New Forest District Council Rebuttal

This document is the rebuttal of Richard Payne Principal Environmental Design Officer NFDC dated 15 September 2023 to the following:-

Proof of Evidence Relating to Matters of Design, Character, Trees & Open Space at Orchard Gate, Noads Way, Dibden Purlieu Hythe, SO45 4PD - Prepared by Paul Harrington BA (Hons) BARCH RIBA Design Director REV C - August 2023 Application Reference 22/10813 Demolition of the existing buildings, erection of 25 dwellings with associated access, landscaping and parking.

Image 24 (p. 27)

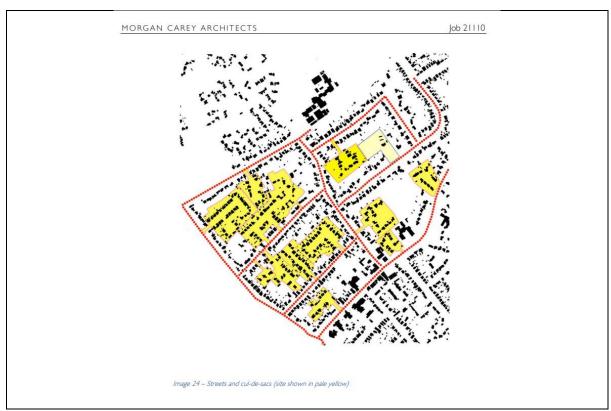
On the face of it, this is a very compelling diagram and might appear to justify the adherence to this way of developing saying that these form the locally distinctive character than should inform design. However, it seems from the descriptions that they are neither appropriately chosen or that they are good examples – the appellant is at pains to criticise their designs and it seems that they are not within sylvan settings or that in their introduction, they have destroyed that element of character, either at the time or over the years.

Overall, the analysis of backland developments given in image 24 is presented as rather a set of precedents for justifying the appellant's approach and while criticising each backland scheme for poor design, it then says that the proposal is consistent with these schemes.
